# 1ST & PIKE

103 PIKE STREET

EARLY DESIGN GUIDANCE 3  
03 APRIL 2018  
DPD #3028428

## 1. TOWER

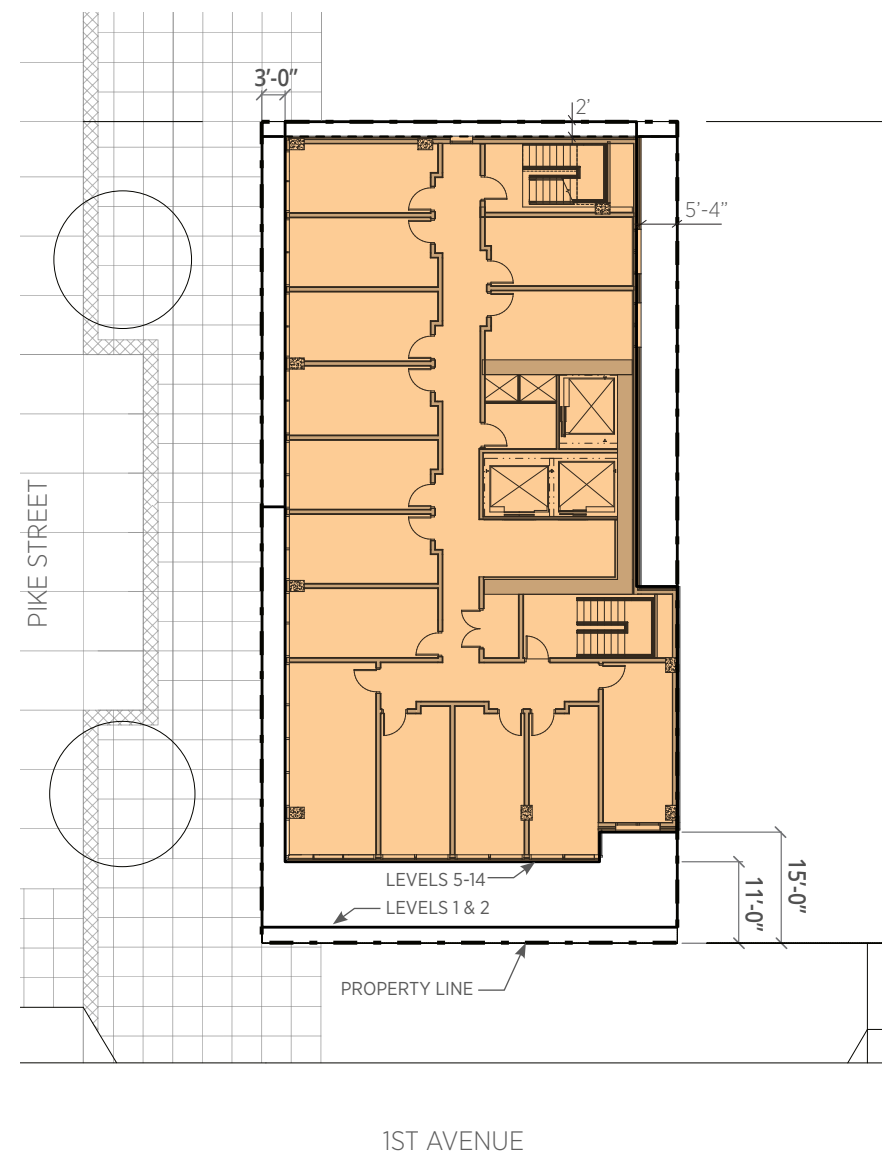
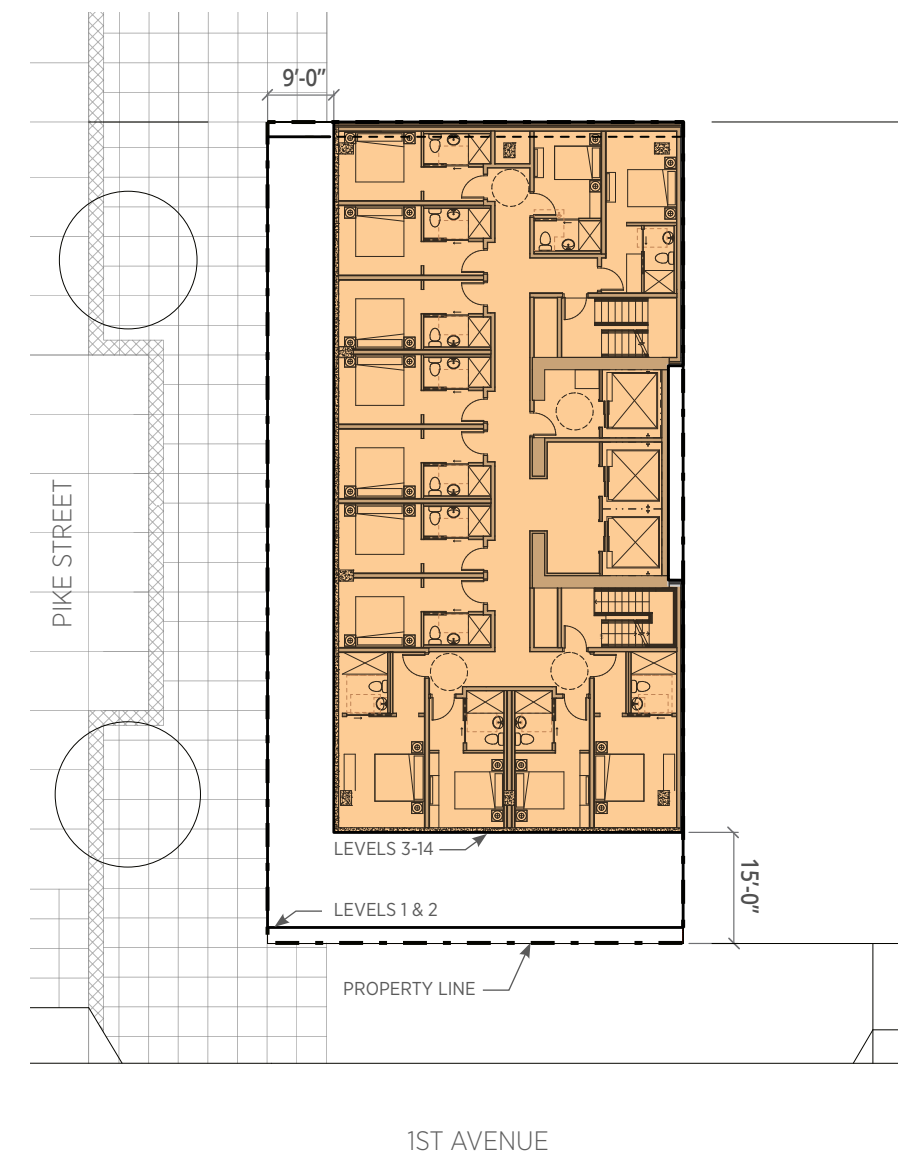
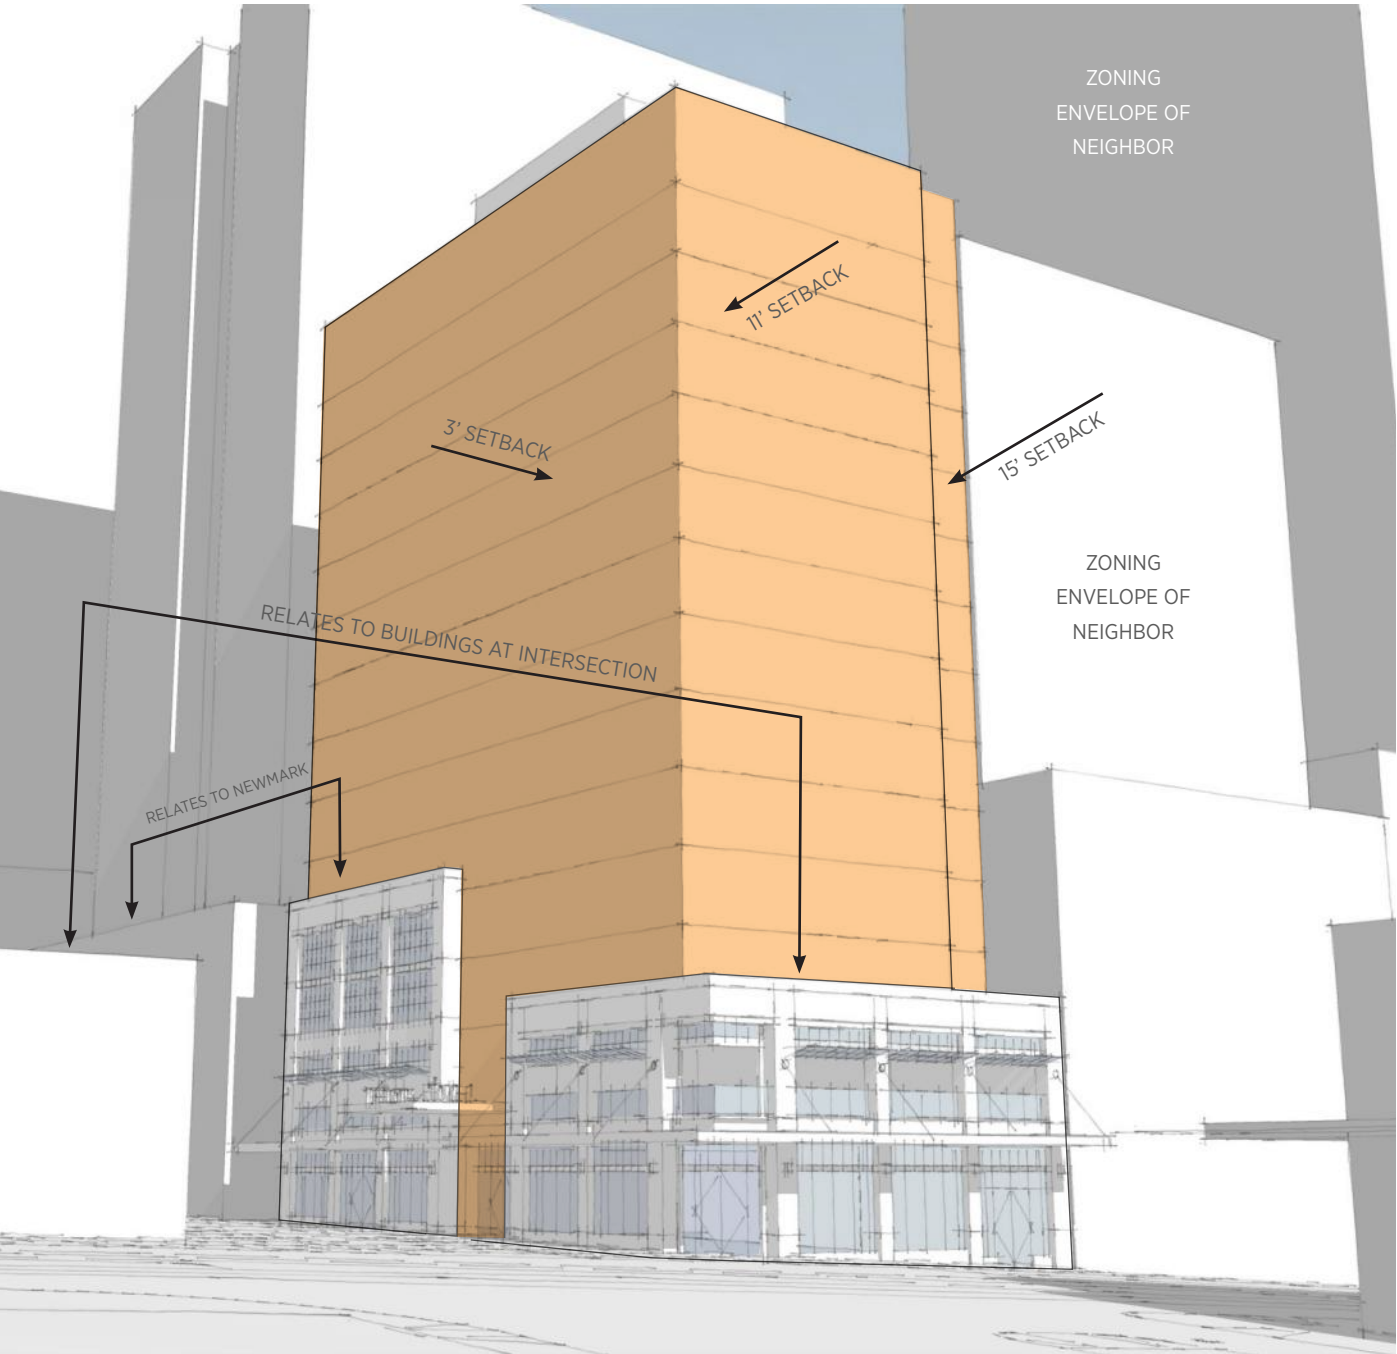
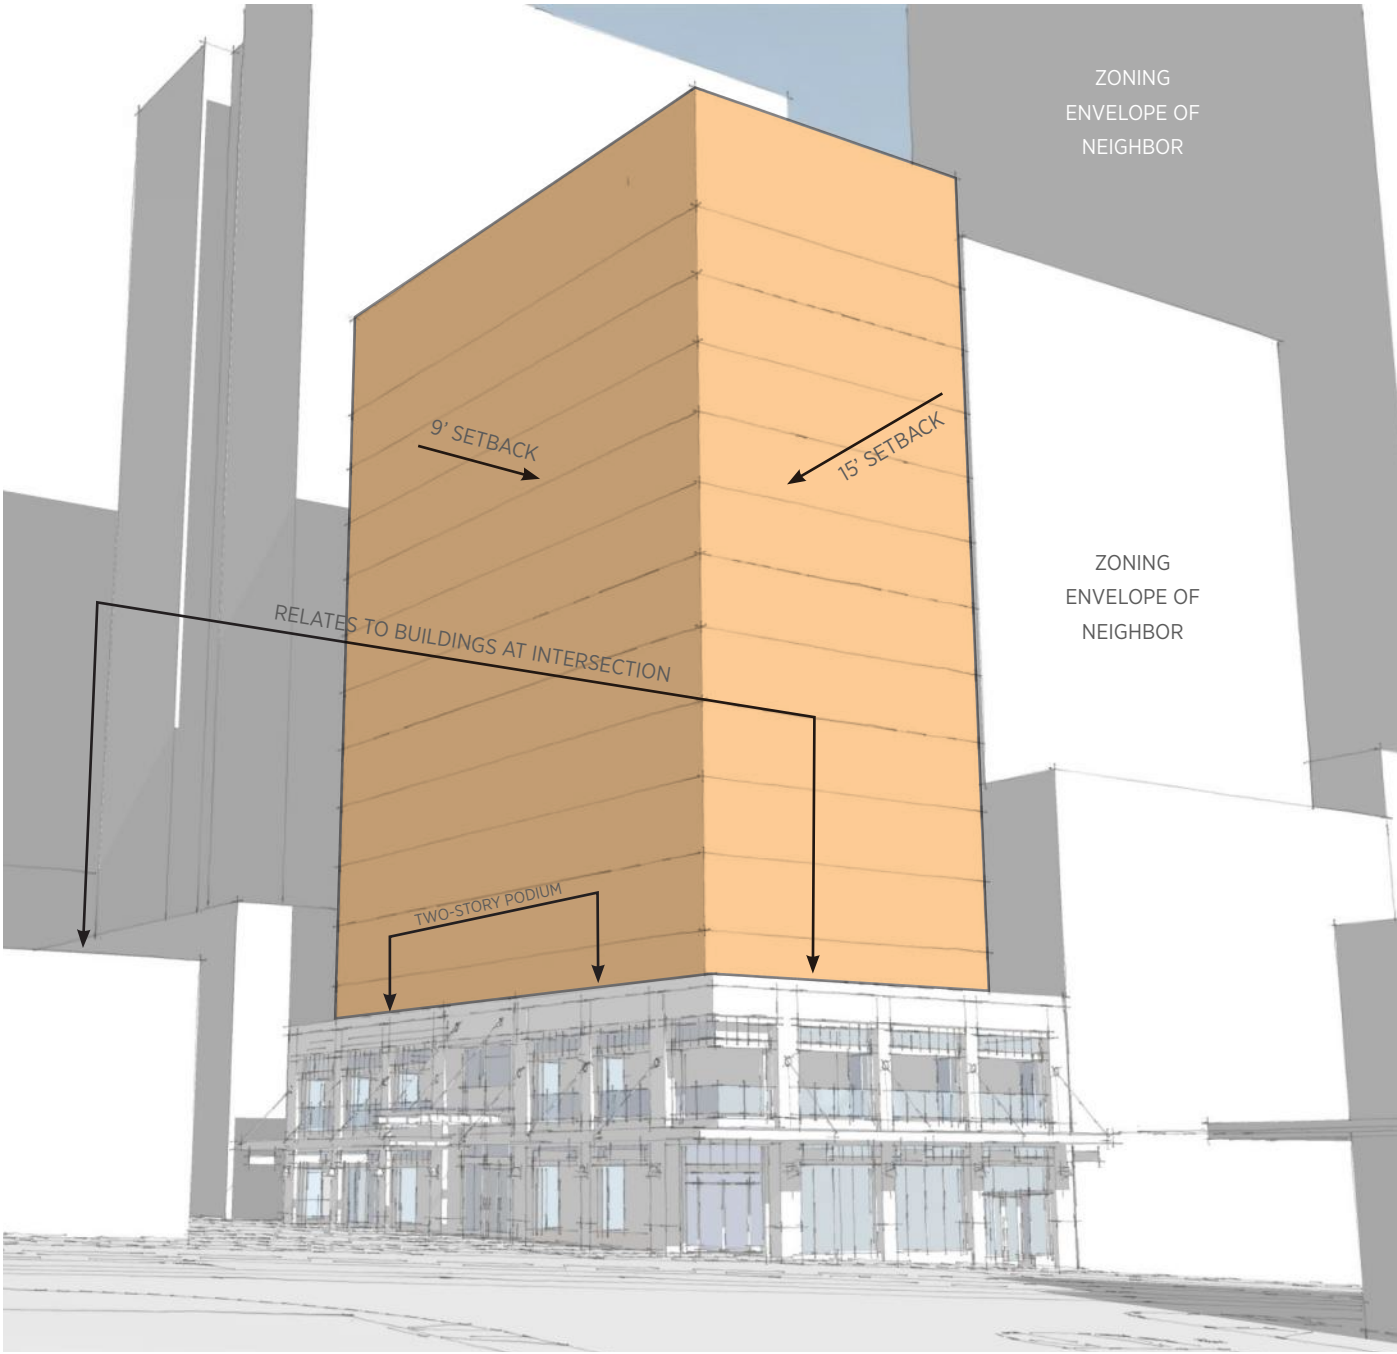
1.a.iv. The Board's comments pertaining to the tower were as follows:

- The Board voiced support for the tower height as shown with the understanding that additional setbacks and scale elements are included in the design to assure that the tower is portrayed as a distinct modern structure counterpoint to the podium that is firmly in the foreground and relates to the four corners of the site. The Board stated that the tower proportions needed further refinement so that the podium is strengthened.
- The Board stated that the distinction between the podium and the tower massing should be volumetric. The Board reemphasized that the tower massing should be set back from the podium on both streets and upon review of the presented massing, stated that a more substantial generous setback (more than 3' as shown) was necessary.

The tower has been refined to emphasize the distinction between the podium and the tower massing. Voluntary setbacks have increased to minimize the towers impact on the site.
